**Addendum No. 2  
January 19, 2024**

Project: **Lennox High School Addition**  
Lennox, South Dakota  
Architecture Incorporated Project No.: 2982

Architect: Architecture Incorporated

**D** BUILDING SECTION - AREA G  
SCALE: 1/8" = 1'-0"

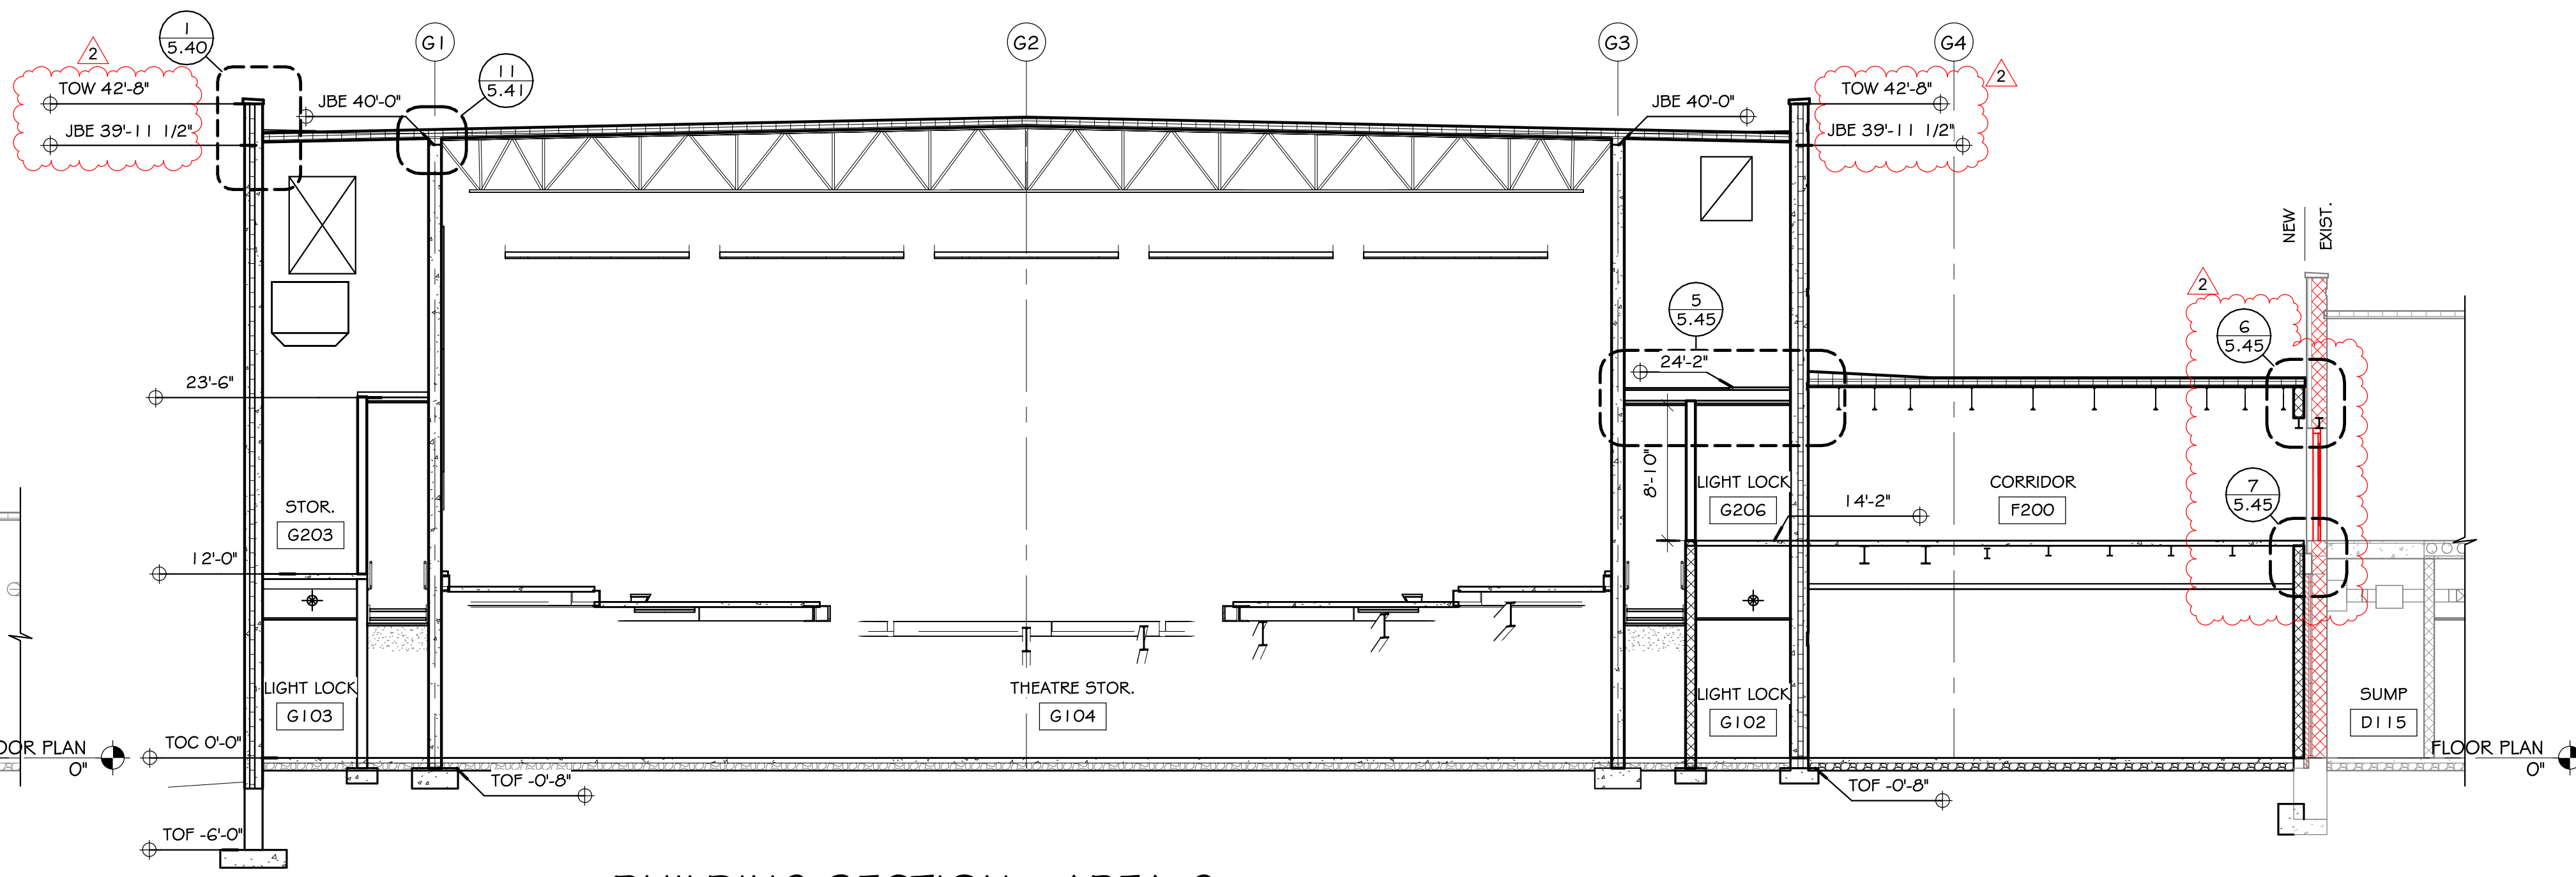
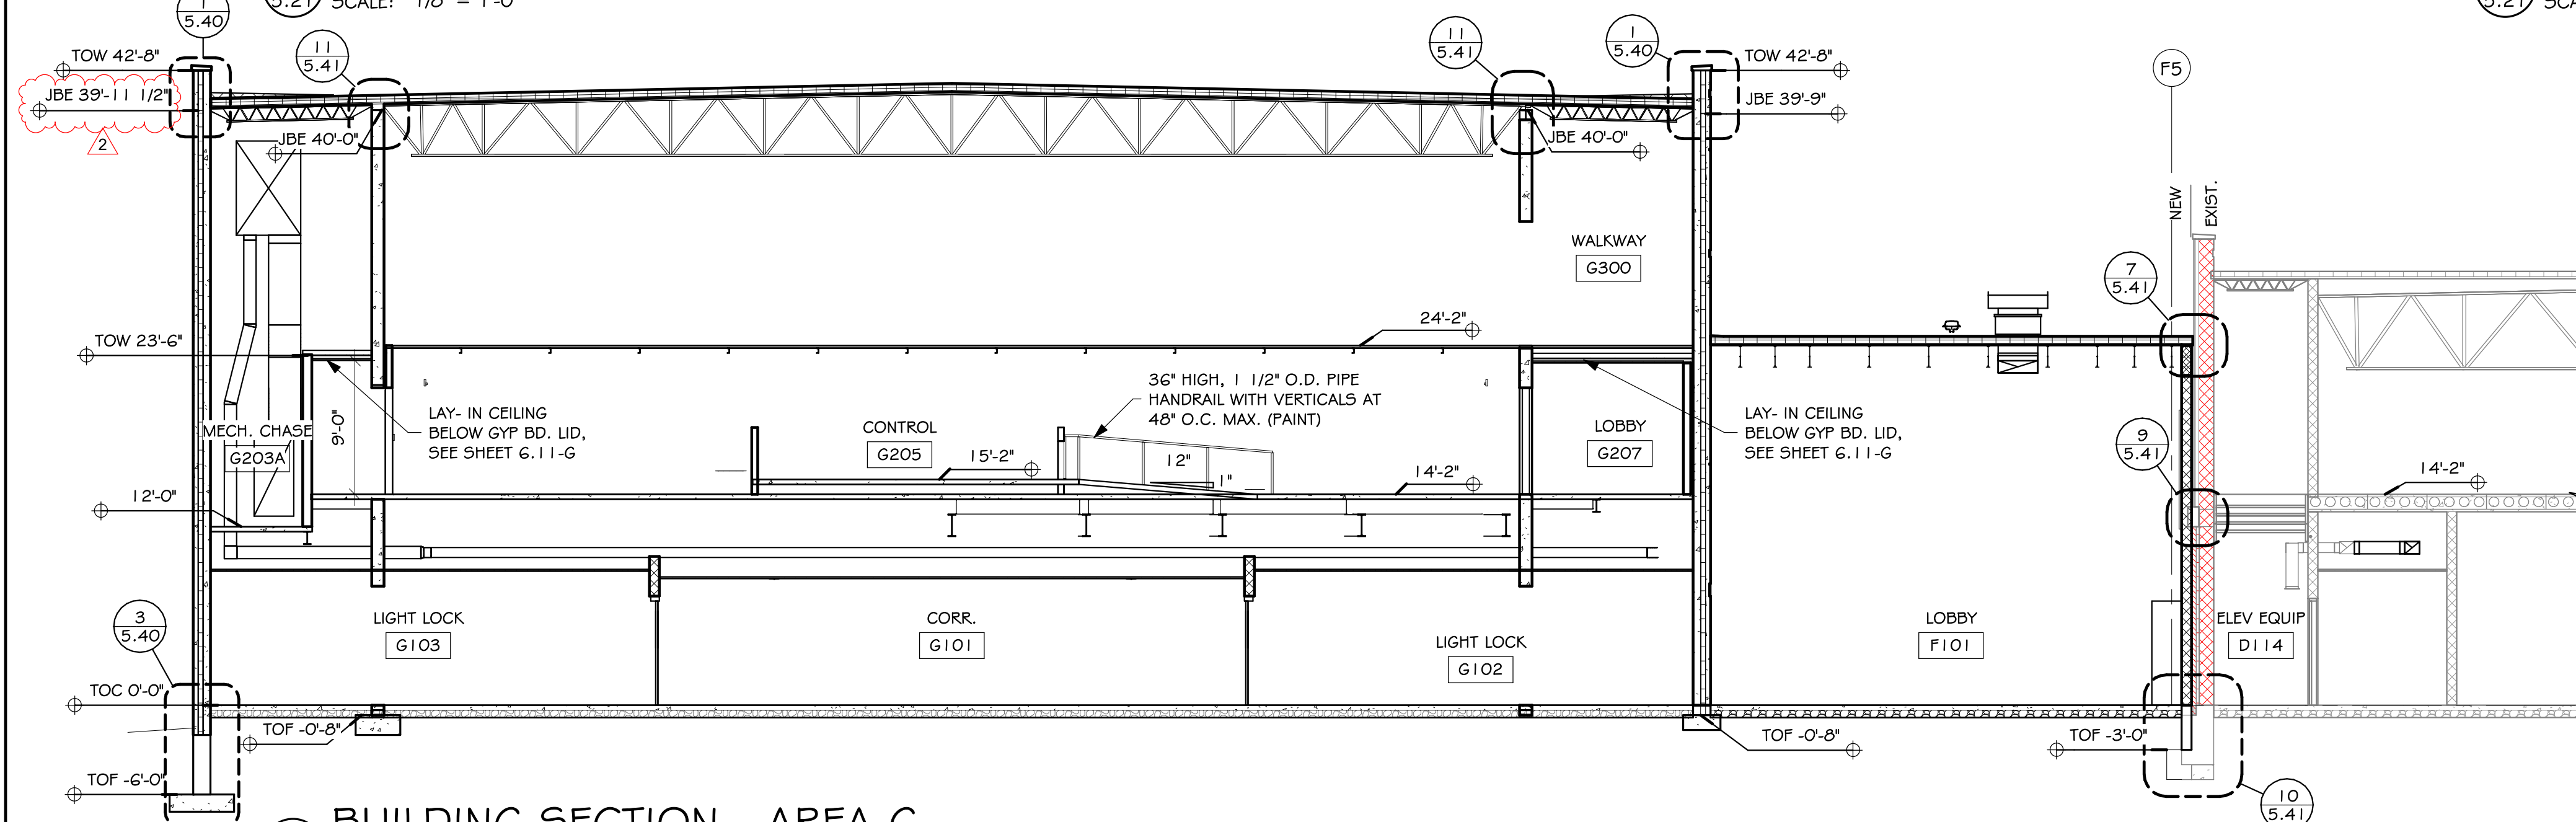
31) SHEET 5.21 – BUILDING SECTIONS

- a) Reference *revised* drawing Sheet 5.21, dated 1-18-24, attached to the end of this addendum for the following:
  - i. Additional wall detail callouts have been added to building sections A, E & F.
  - ii. Top of wall elevations have been added to building section E.
  - iii. Joist bearing elevations have been added to building sections B, C, E & F

6 DETAIL - AREA F  
SCALE: 1 1/2" = 1'-0"

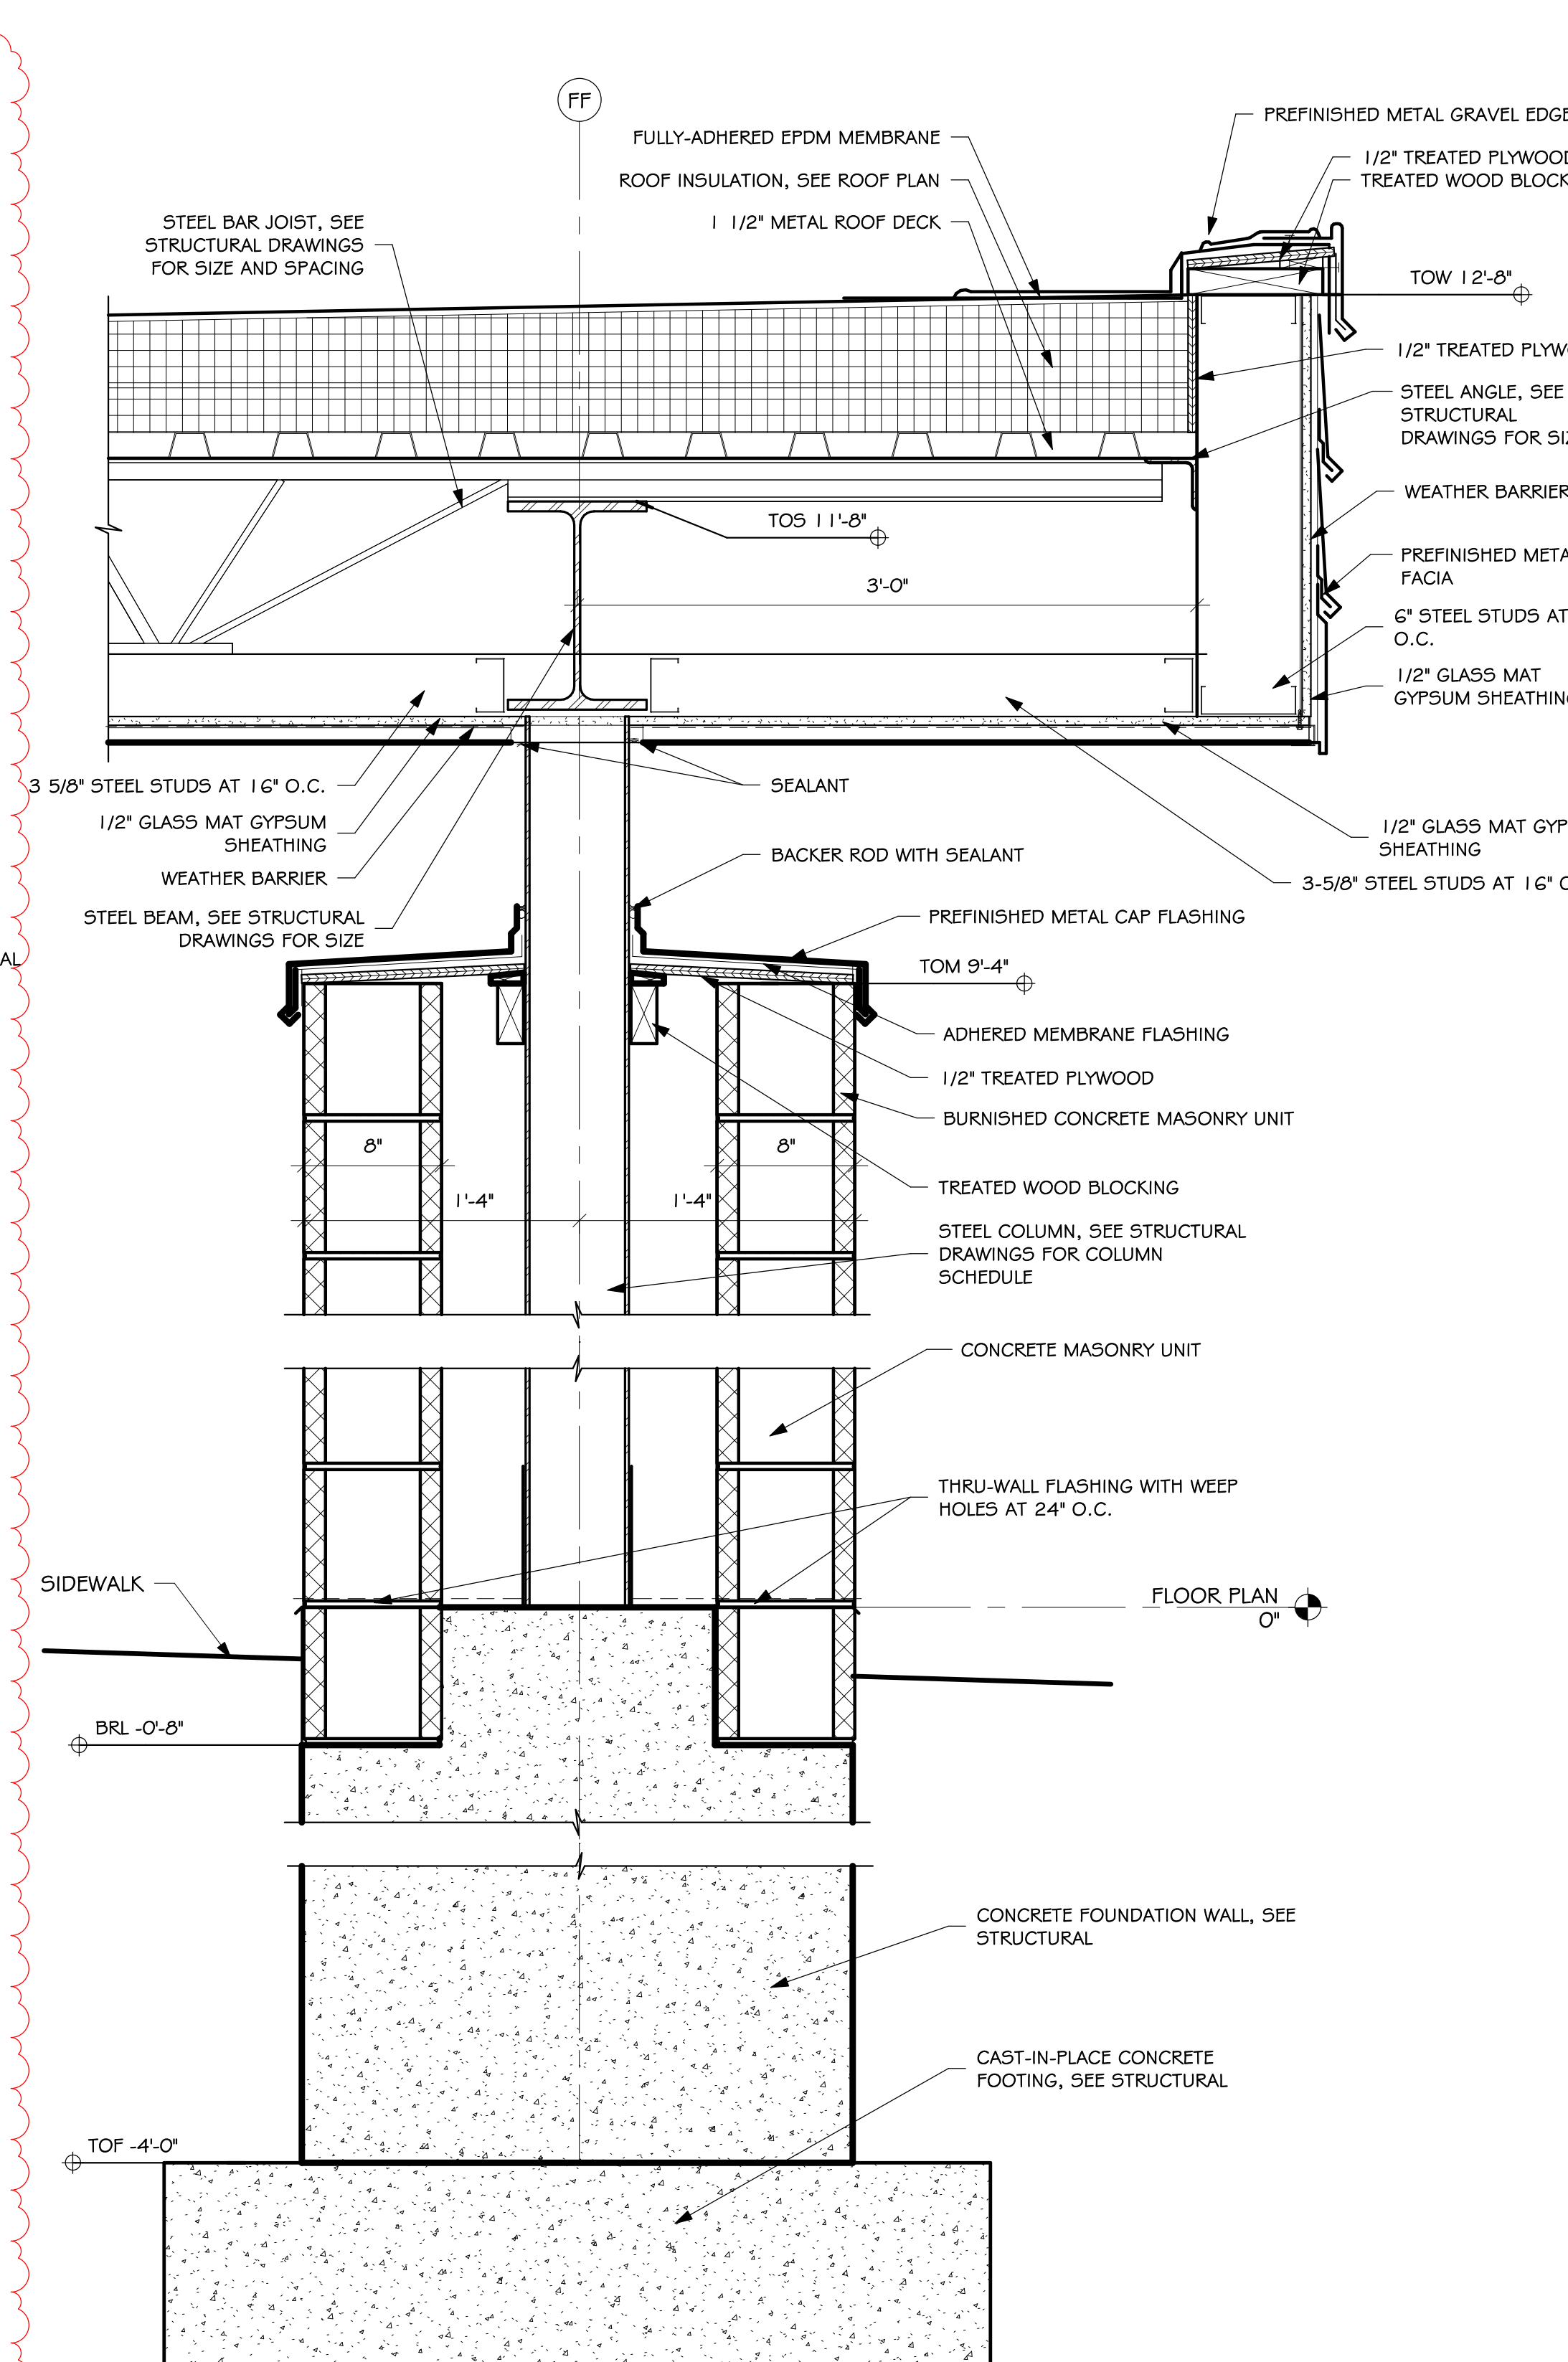
36) SHEET 5.45 – SECTION DETAILS

- a) Reference *revised* drawing Sheet 5.45, dated 1-18-24, attached to the end of this addendum for new head detail 6/5.45 and new sill detail 7/5.45 at door F200-2. These details are called out in building section E/5.21.
